## ORIGINATION FORM

Proposed Revisions to a Standard Plans Index  
(Please provide all information — Incomplete forms will be returned)

Index Number: 521-512

Index Title: Concrete Barrier /Noise Wall - Junction Slab

SECTION B-B  
TYPICAL SECTION THRU JUNCTION SLAB AND RETAINING WALL

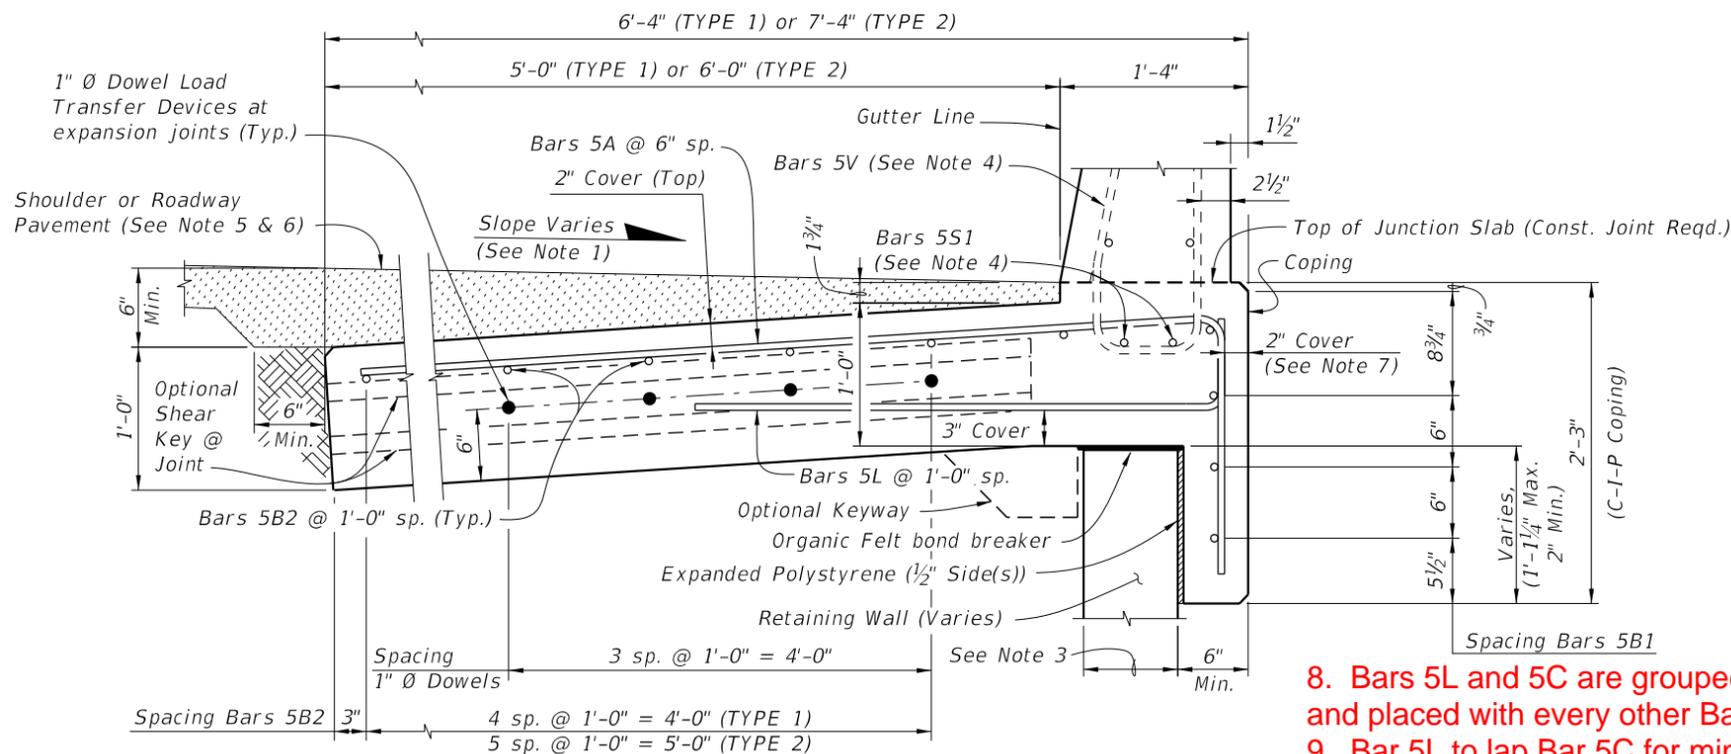
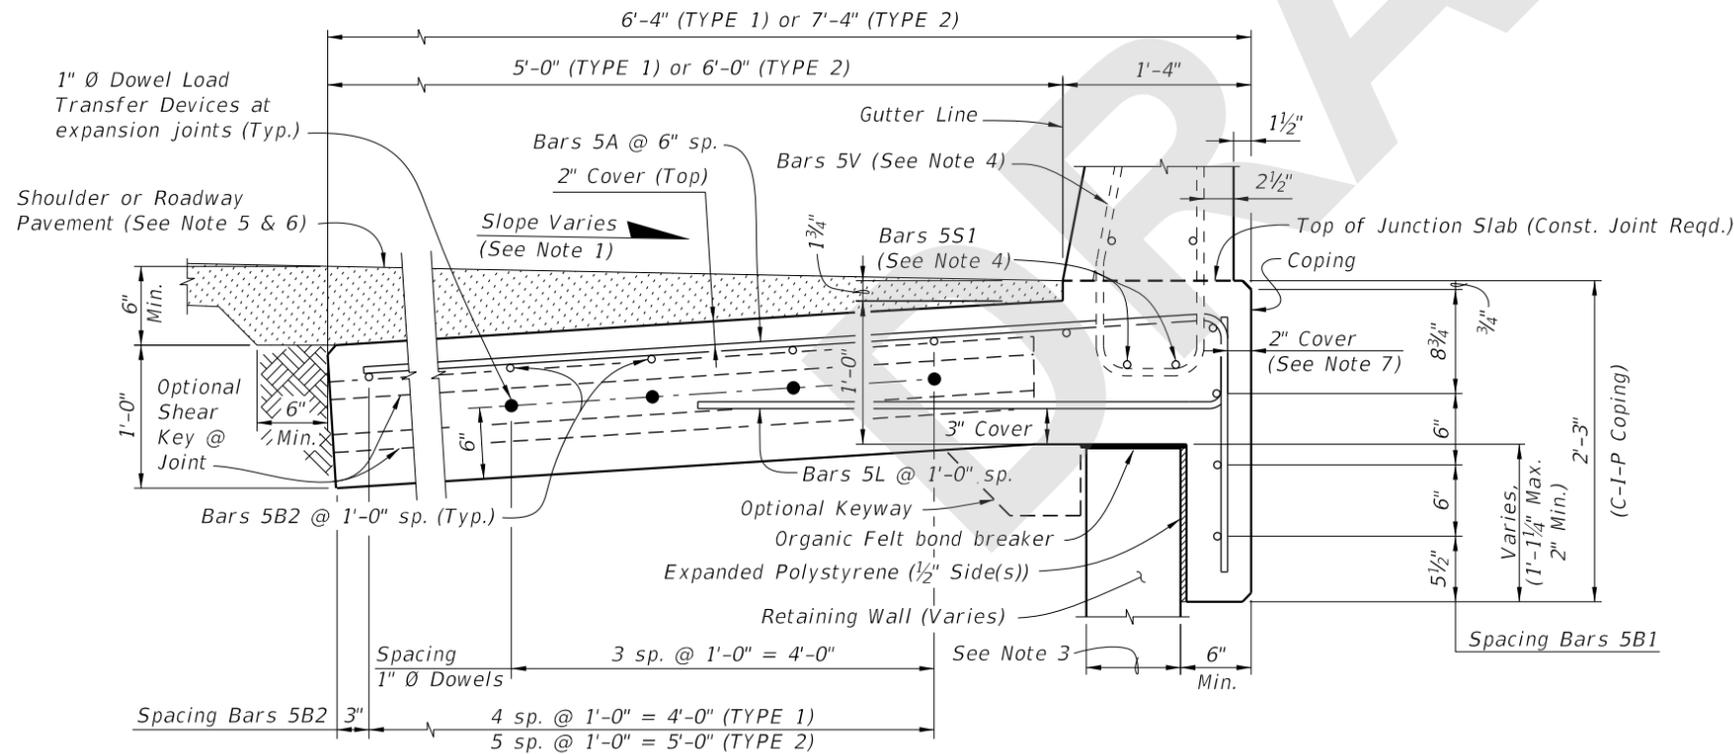
Changed Title; Sheet 2 Changed Notes 5 & 6, Added notes 8 & 9

Note 8 & 9 from D-6. Notes 5 & 6 changes to match other Indexes.

1. Match Cross Slope of Travel Lane or Shoulder.
2. Vary Junction Slab slope based on roadway cross slope to maintain a minimum 6" asphalt depth at the edge of the slab as shown.
3. Actual width varies depending on type of Retaining Wall used.
4. See Index 521-510 for Bars 5V and Bars 5S1.
5. For Rigid Pavement (Concrete), Junction Slab may be thickened to match finished grade.
6. See Roadway Plans for asphalt shoulder, roadway pavement and overbuild.
7. If slip forming is used, submit shop drawings for approval showing Expansion Joint support details and 1/2" side cover with adjusted Typical Section dimensions.

8. Bars 5L and 5C are grouped together and placed with every other Bar 5A.
9. Bar 5L to lap Bar 5C for minimum wall embedment. Minimum Lap splice length 2'-2".

1. Match Cross Slope of Travel Lane or Shoulder.
2. Vary Junction Slab slope based on roadway cross slope to maintain a minimum 6" asphalt depth at the edge of the slab as shown.
3. Actual width varies depending on type of Retaining Wall used.
4. See Index 521-510 for Bars 5V and Bars 5S1.
5. For Rigid Pavement (Concrete), Junction Slab may be thickened to match finished grade. Vary the Junction Slab slope to maintain a minimum 1'-6" thickness at the inside edge of the slab.
6. See Roadway Plans for asphalt shoulder, roadway pavement and overbuild.
7. If slip forming is used, submit shop drawings for approval showing Expansion Joint support details and 2 1/2" side cover with adjusted Typical Section dimensions.
8. Bars 5L and 5C are grouped together and placed with every other Bar 5A.
9. Bar 5L to lap Bar 5C for minimum wall embedment. Minimum Lap splice length 2'-2".
